- 1. Surreal Subdivision 2023; KPB File 2023-137  
Geovera, LLC / Daugharty, Greer, Cronland  
Location: Elliot Court & Nearly Level Road  
Diamond Ridge Area / Kachemak Bay APC**

# KPB 2023-137

**ITEM #1 - PRELIMINARY PLAT  
SURREAL SUBDIVISION 2023**

<b>KPB File No.</b>	2023-137
<b>Plat Committee Meeting:</b>	March 25, 2024
<b>Applicant / Owner:</b>	Timothy Daugharty, Sandra Cronland, William Day & Kim Greer all of Homer, Alaska
<b>Surveyor:</b>	Stephen Smith / Geovera, LLC
<b>General Location:</b>	Diamond Ridge Homer area / Kachemak Bay APC

## SURREAL SUBDIVISION 2023

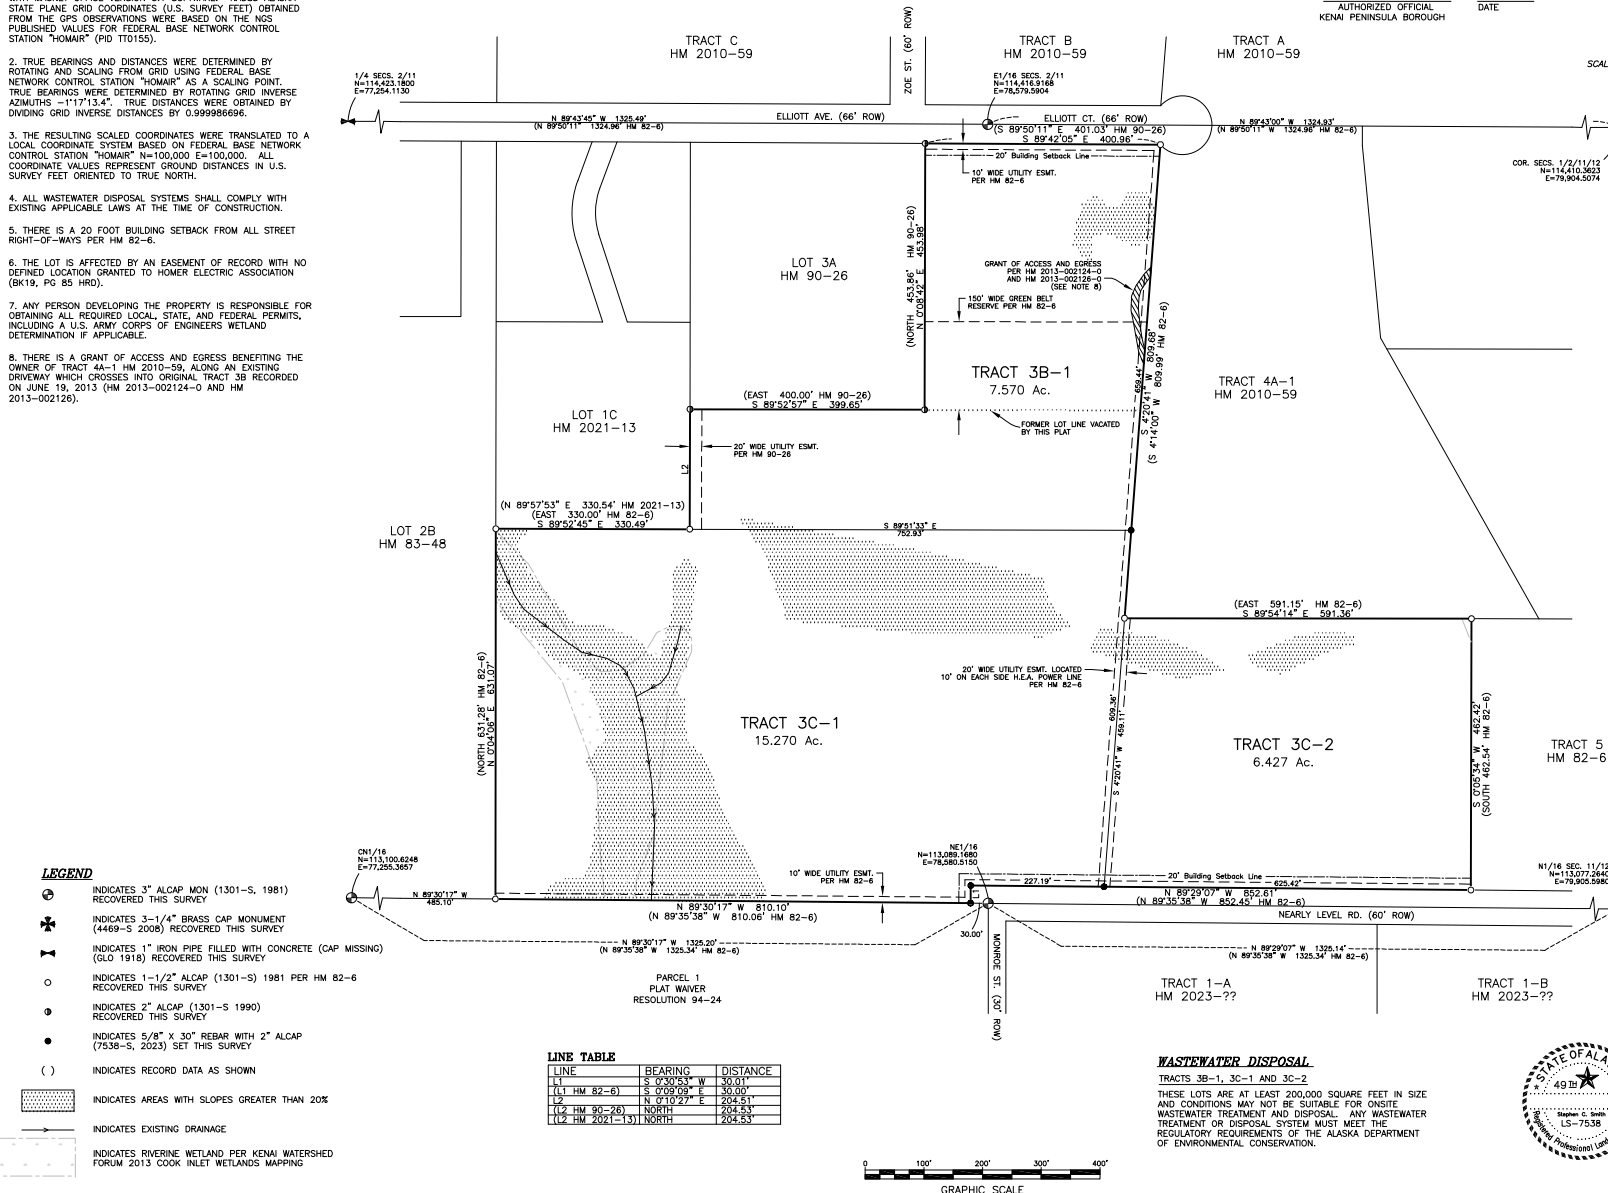
There is a 20' utility easement shown on the west line of proposed Tract 3B-1 that was carried forward from HM 90-26. Also shown is a 10' utility easement on both sides of an existing powerline on the easterly side of the plat. HEA has requested that this easement be expanded to be 15 feet on each side of the power line by adding 5 feet each

side. **Staff recommends:** add the 5' to easement side along with a plat note stating easement is now 15' on each side of the HEA power line, granted this plat.

Add a 10 foot utility easement and plat note to the front along all right-of-ways.

- Recorded data from CN1/16 to southwest corner of subdivision needed.
  - Add the plat note; No permanent structure shall be constructed or placed within a utility easement which would interfere with the ability of a utility to use the easement.
-

- Change KPB No to 2023-137.
- Please verify the legal description of the designation of lots or tracts from HM 90-26. CTP and various items in CTP both use lot and tract. KPB GIS uses lot in their data.

Ad some streets and names to vicinity map, to get to the site location.

Green belt easement needs correct plat label to it and a plat note added.

Lots to the southeast need plat labels to be 2023-45

HEA requested extra easement width on existing easement.

Easement in bk 211 Pg 948 affect the property access and should be noted on the plat.

- Revise the date in Plat Note #8 to July 5 for correctness to documents.
- Transfer forward plat notes from previous plats.
- Include a note for 10' utility easement along front right-of-way.

Add the date March 25, 2024 to the Plat Approval
